SCC 2023-0045 – Former Brockhurst Care Home Outline Planning Application - ONF Representations

Summary Statement.

Fig A-1.1: Ottershaw Village Centre Character Area.

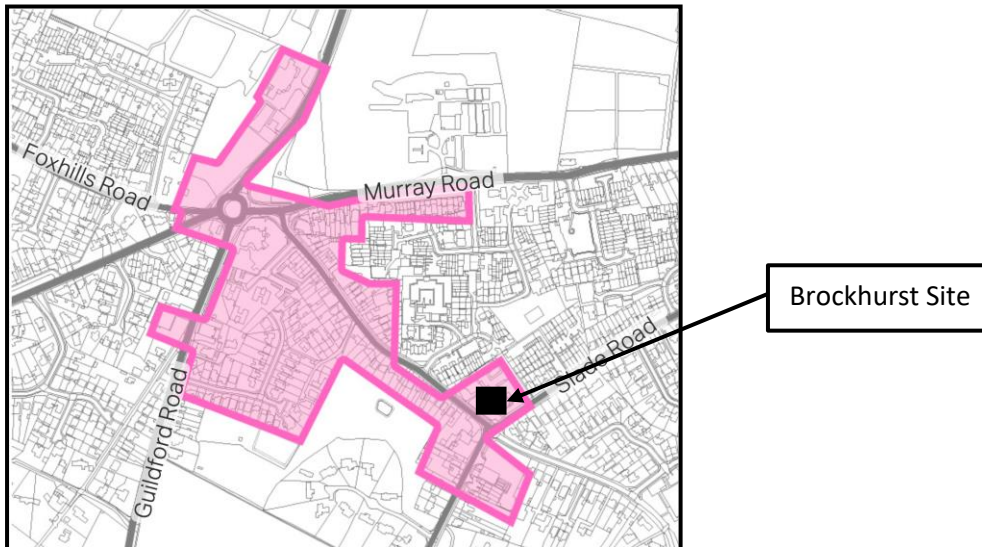
The Brockhurst site is located at the southern tip of the Village Centre Character Area (Ref: Ottershaw Draft Neighbourhood Plan).

Fig A-1.3: Proposed Solution – Frontage onto Brox Road (from Design & Access Statement)

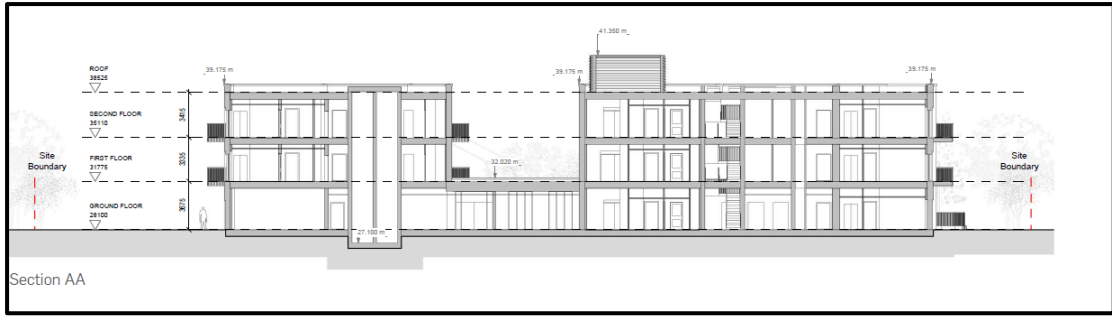
Brockhurst Frontage onto Brox Road. The proposed frontage, whilst being set back a similar distance as the previous build from the boundary, has a full building width frontage of flat façade, 3 storeys high with a flat roof and services on the roof also visible. (Fig A-1.3). The implied design at this outline **stage is one which takes no cues from the surrounding area at all.** If not addressed in some way at this stage this unacceptable design will be irreversible. The intent is to try to “hide” the development rather than integrate it. This has clearly not been achieved.

Fig A-2.6 Proposed new Development – Proximity to Corner Slade/Brox Roads.

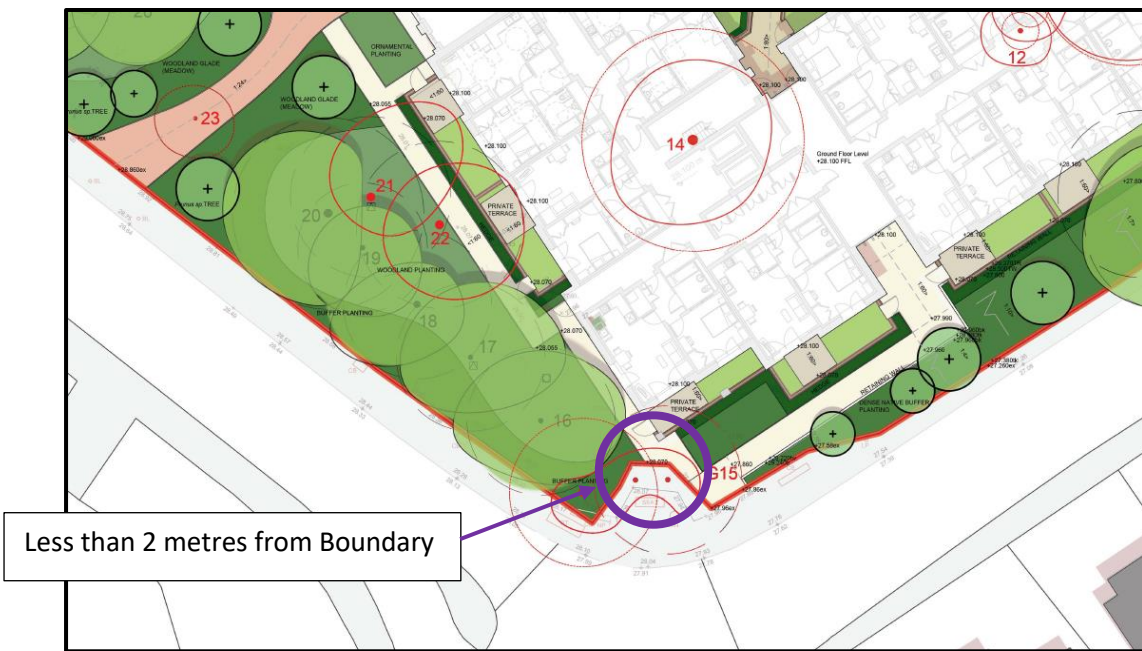
The corner of the proposed new build (3 storeys at this point) is **within 2metres of the property boundary and unmasked by any vegetation or trees. This is far too close** and emphasises the overbearing effect of the building whilst also affecting utility and limiting free movement around the building.

It should be noted that the tree shaded seat on the corner of Brox and Slade Roads will be completely compromised through the loss of all the trees and proximity of the new building to the boundary (see Fig A-2.6).
